Re: **LETTER OF TRANSMITTAL  
ROOMS TO GO STORE EXPANSION AND REMODEL  
18722 South Dixie Highway  
Cutler Bay, FL 33157  
POST BID ADDENDUM #5**

## **POST BID ADDENDUM NO. FIVE**

Incorporate the following revised CASCO drawings dated 01/29/2024, with revisions including, but not necessarily limited to, those listed below:

**8 REFLECTED CEILING PLAN**  
A2.0 SCALE: 1/4" = 1'-0"

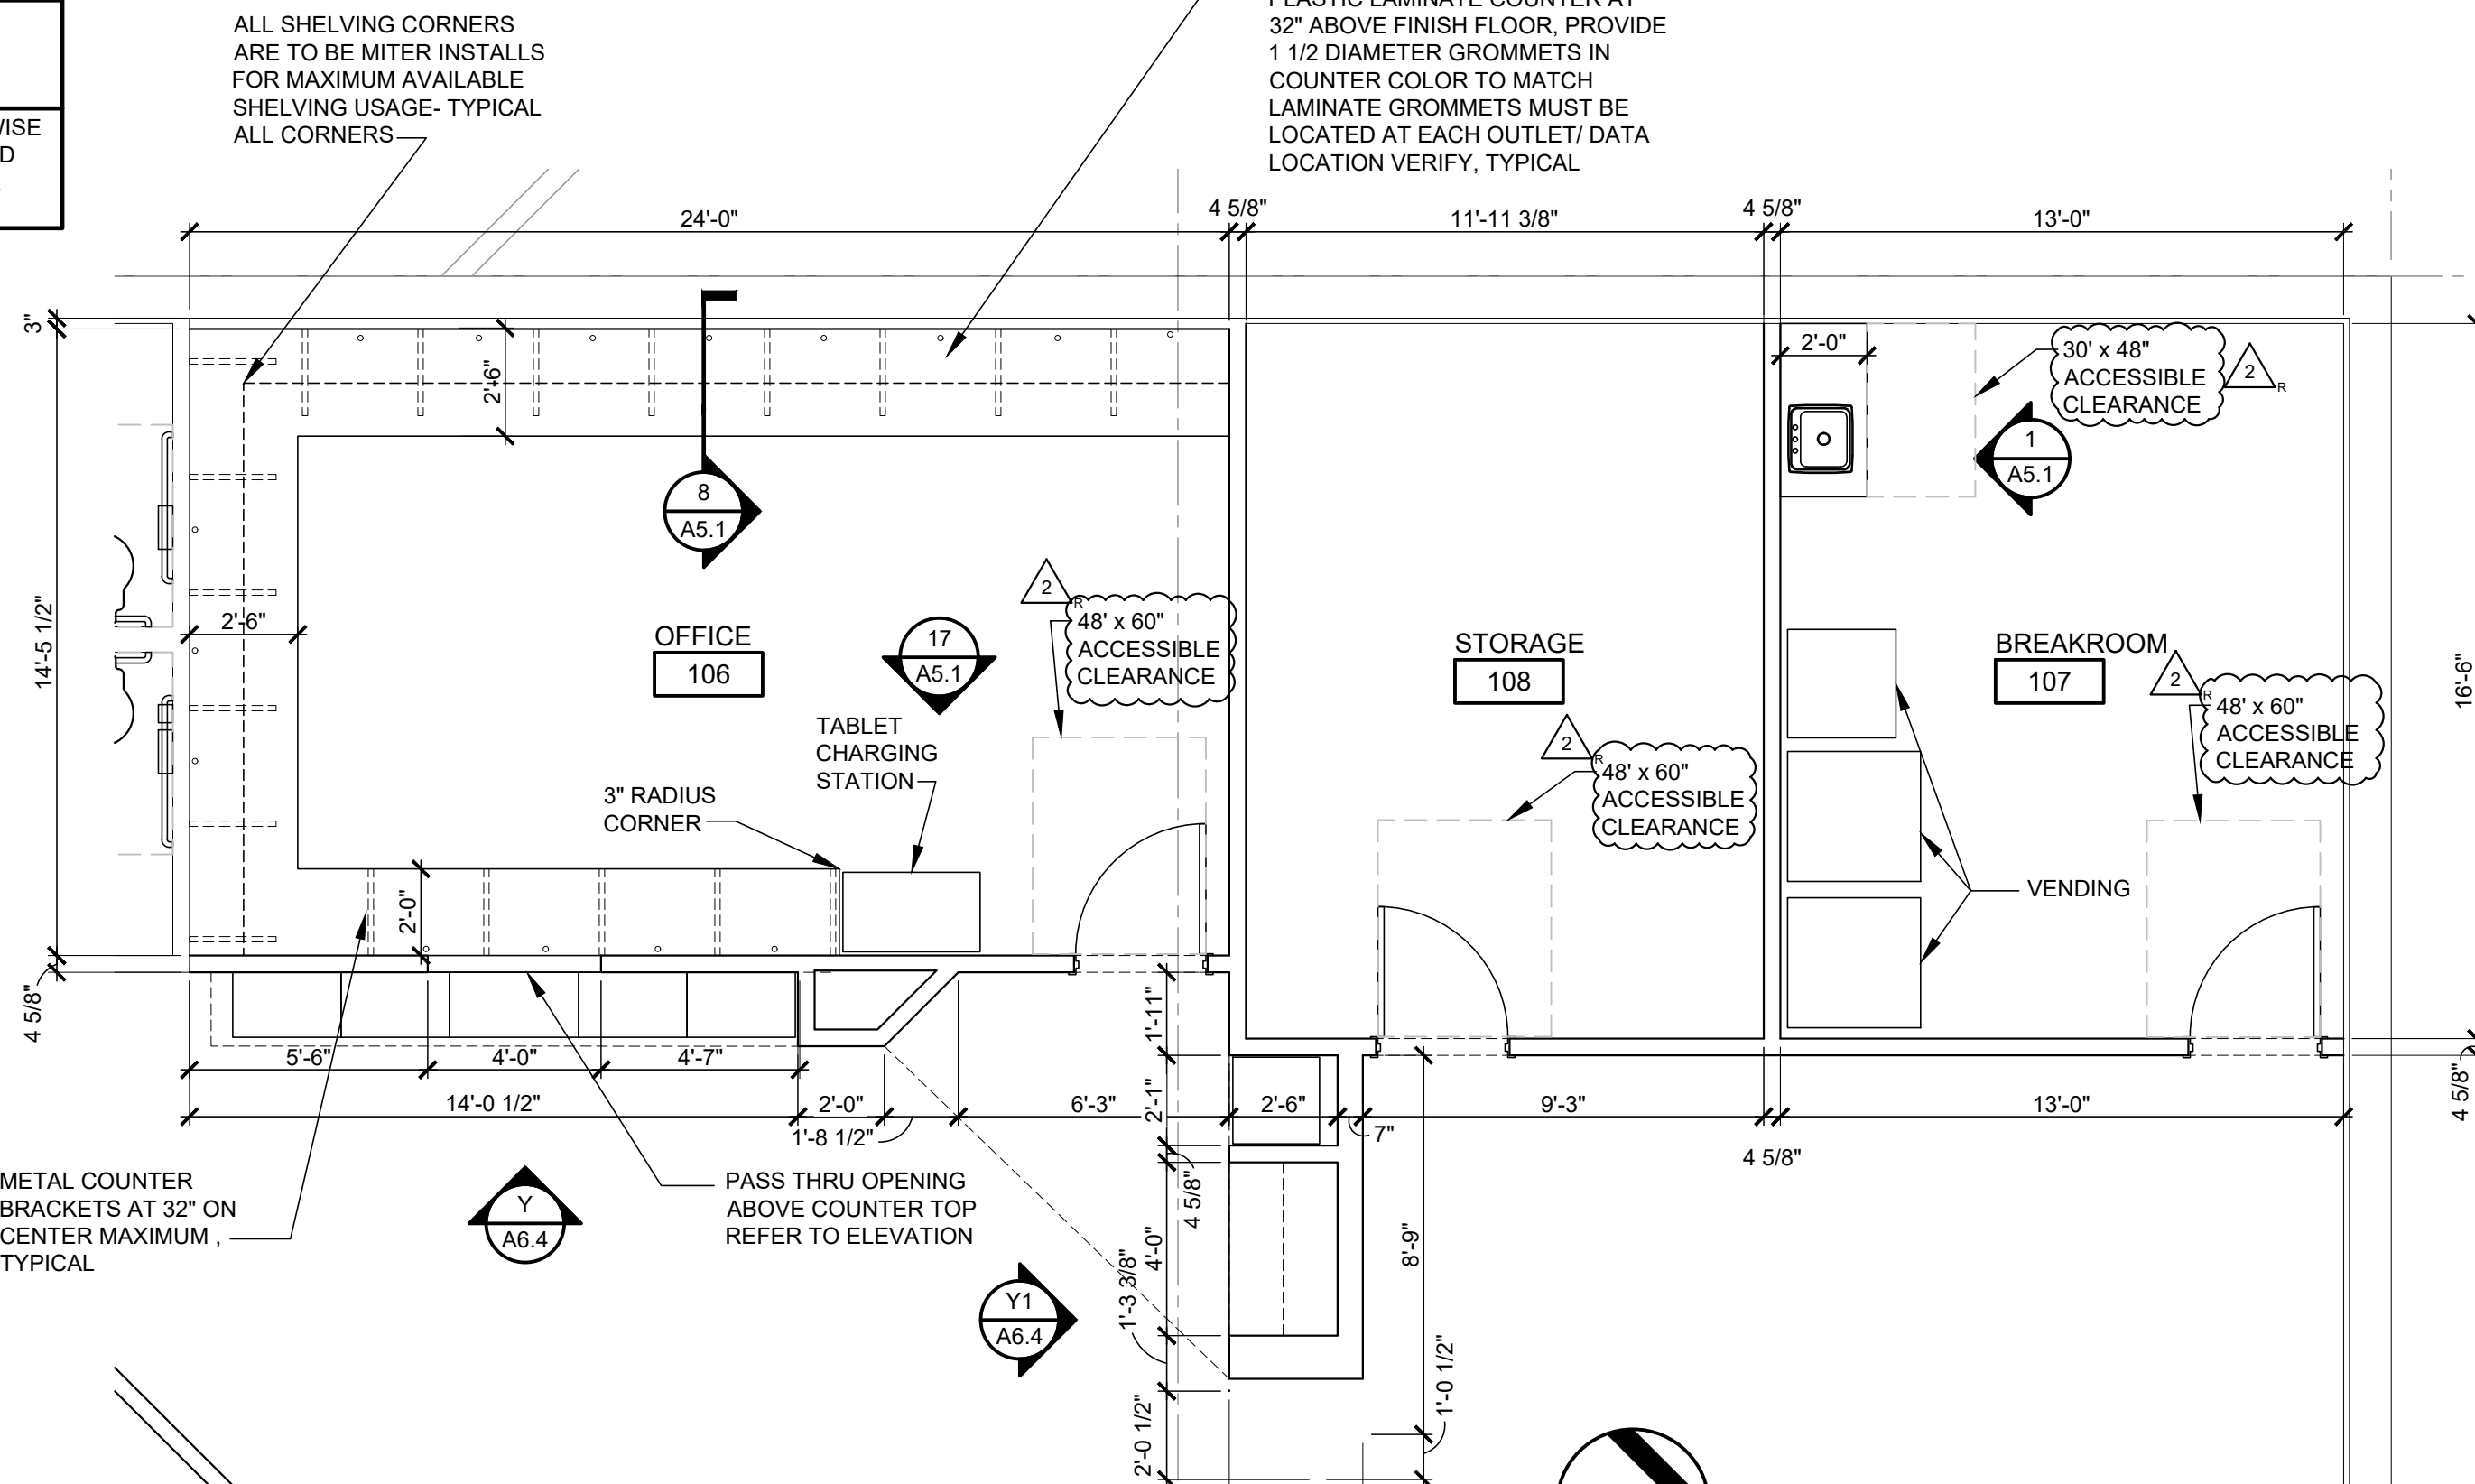
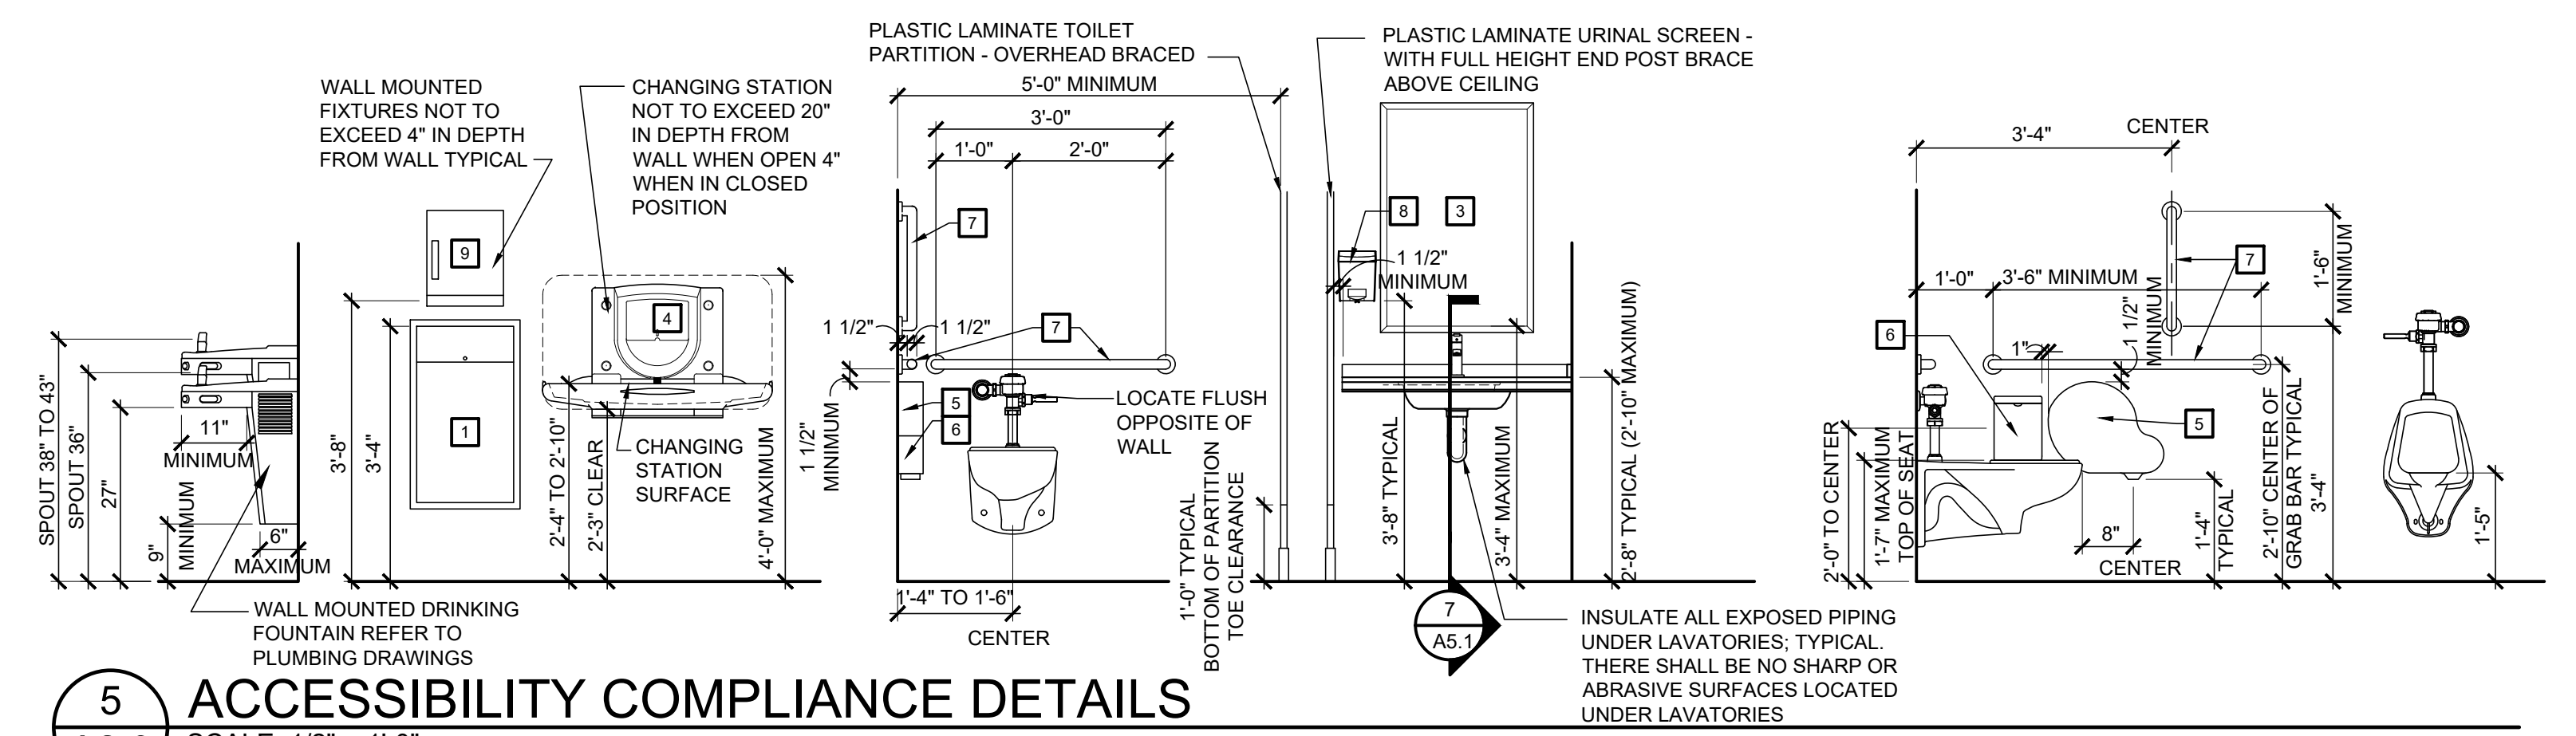
9. Sheet A2.0 – Revision No. 2: Added notes re: 48” X 60” accessible clearance at doors. Added note re: 30” X 48” accessible clearance at Break Room Cabinet. Deleted IDF Room #117.
